Addendum No. 2 INVITATION FOR BID NO.: 09-12 Modernization of Building 2200, First Floor Remodel - Chabot College

Chabot College Modernization
of Building 2200
Chabot-Las Positas Community College District
HMC # 3342003, DSA #01-110263

ADDENDUM NO. 2

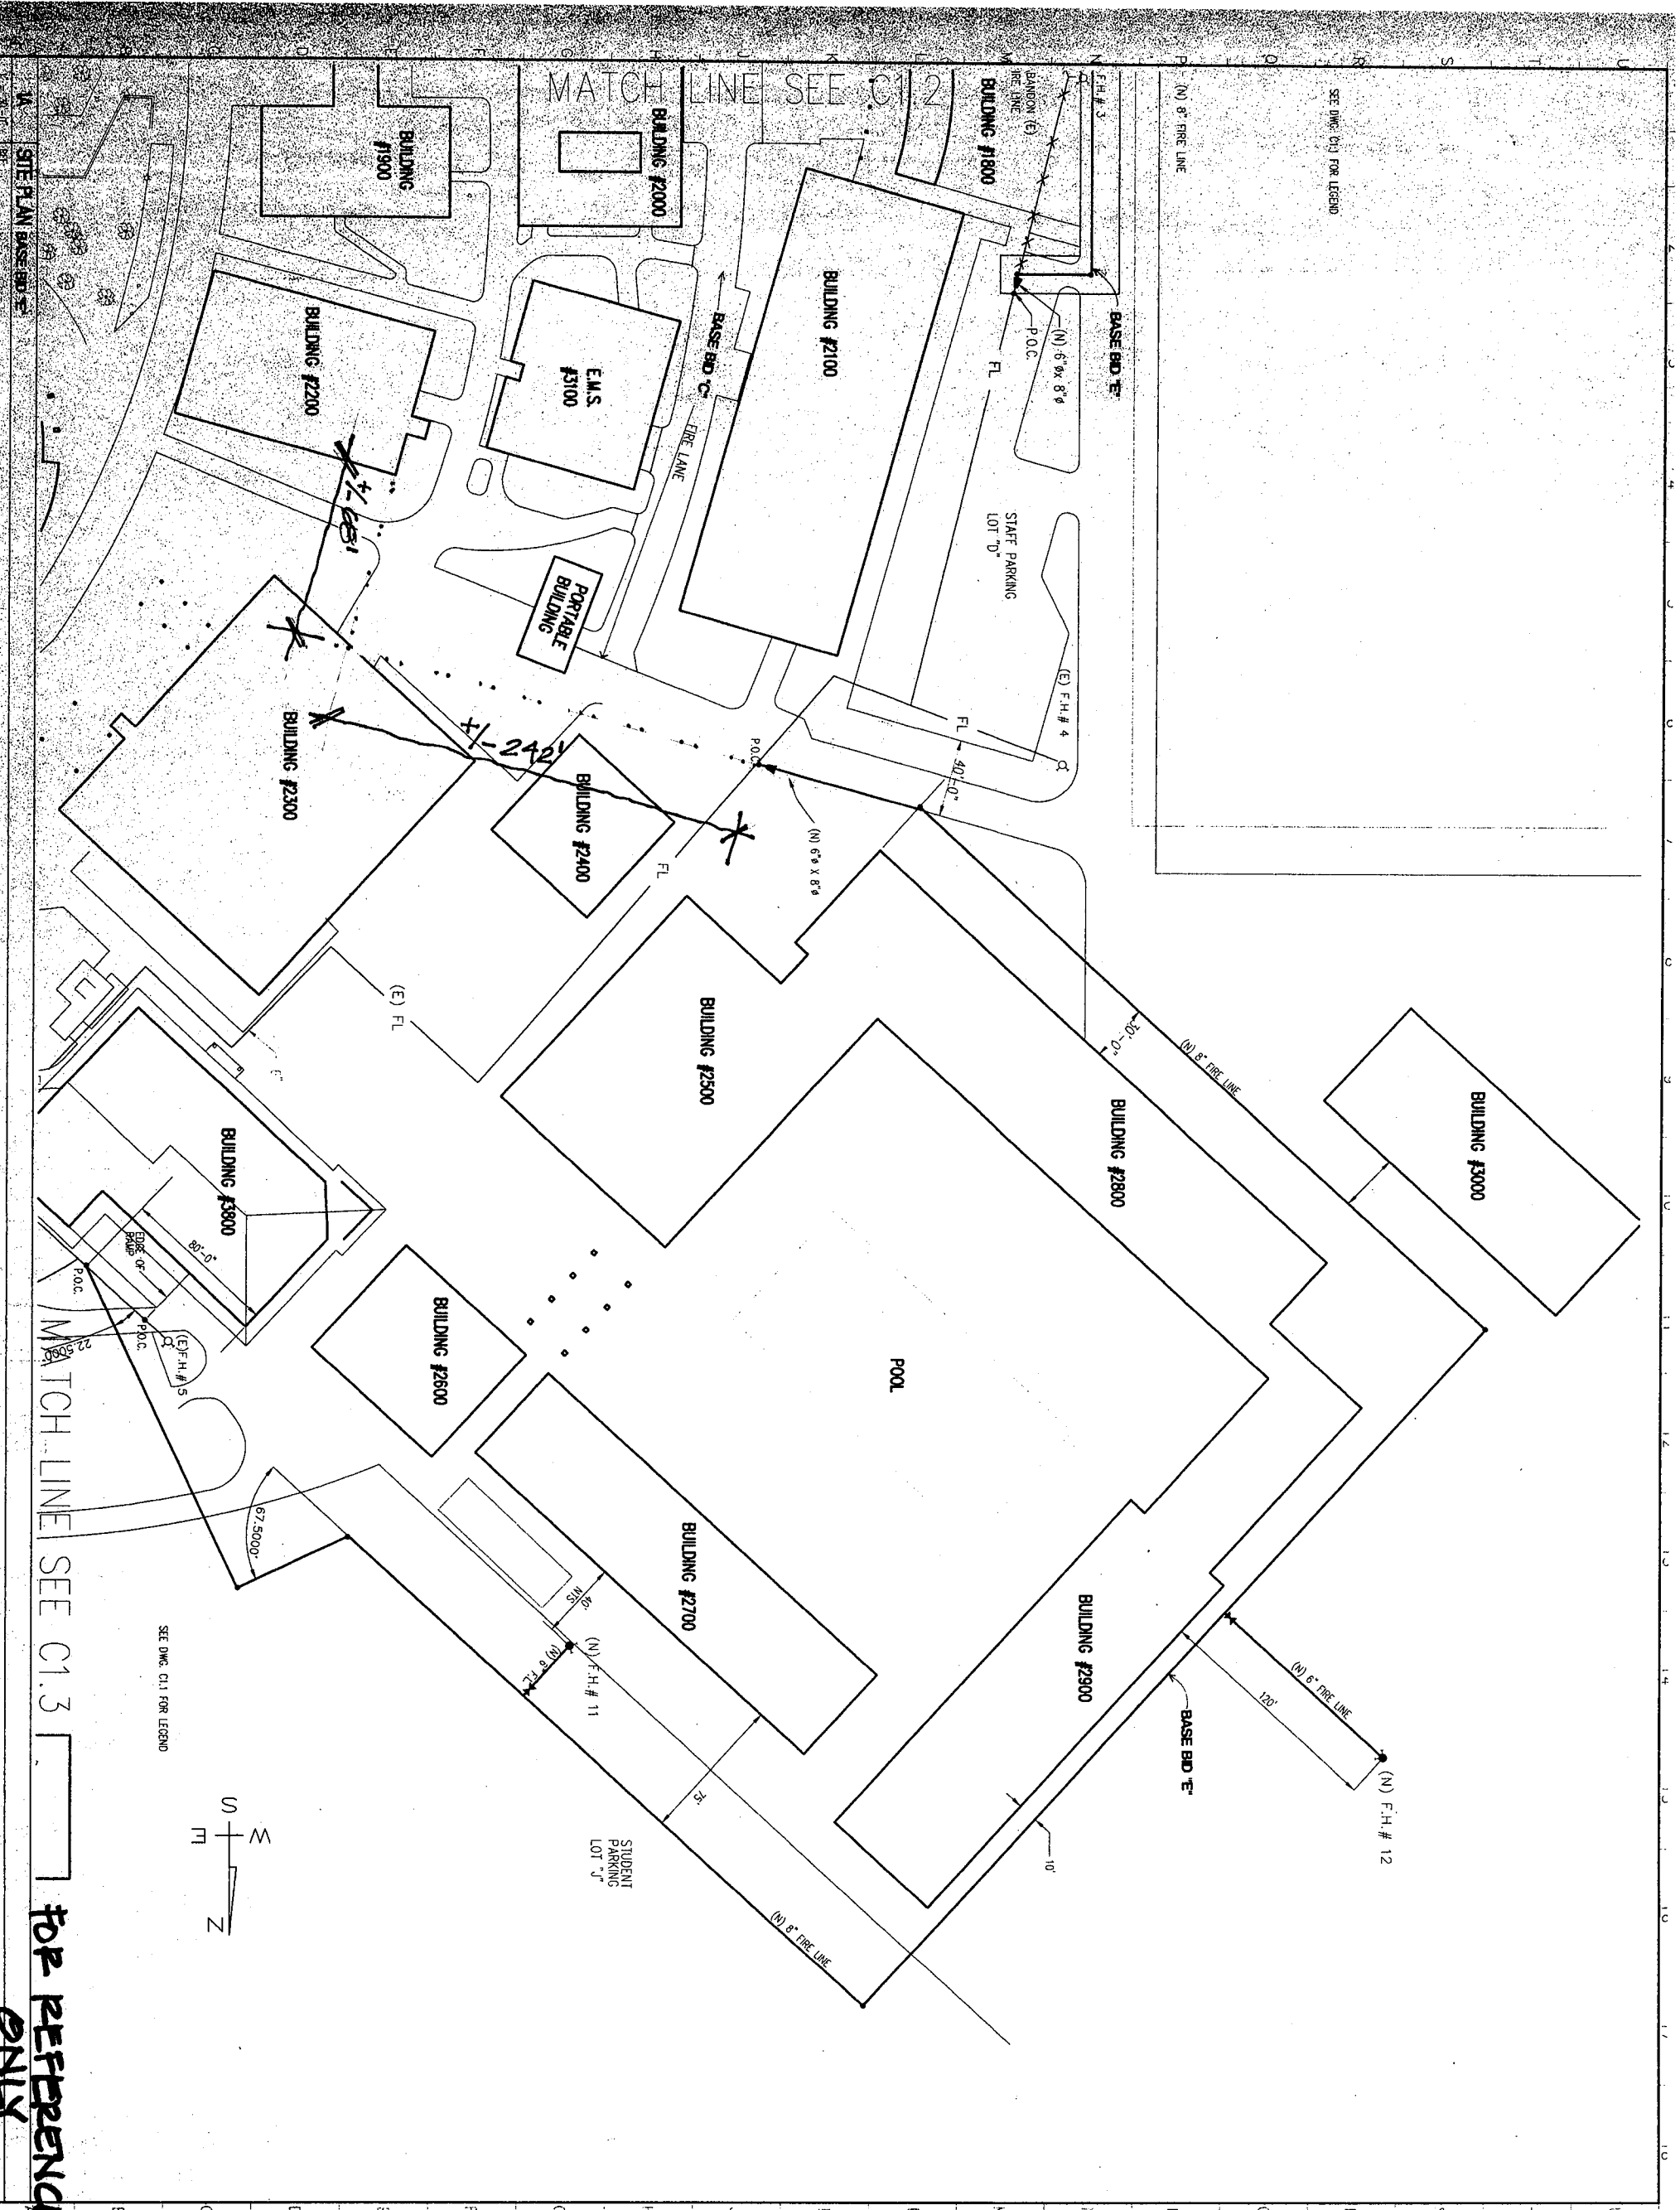
Company Name: <u>Rossi Builders Fx 415-777-1505</u>	
Date: <u>3</u>	Ref Sheet No.:
Bid Question: <u>Concerning Automatic Fire Sprinklers</u> <ul style="list-style-type: none"> • Please give the location of the on-site existing water supply tie-in for Fire sprinkler. • Please give distance from building and the directional side of the building. 	
Response: <u>See enclosed drawing C 1.4 for reference and location of on-site fire line.</u>	
Respondent: <u>K Rubio, HMC</u>	<u>8.19.20</u>
Response cc:	All Bidders via fax
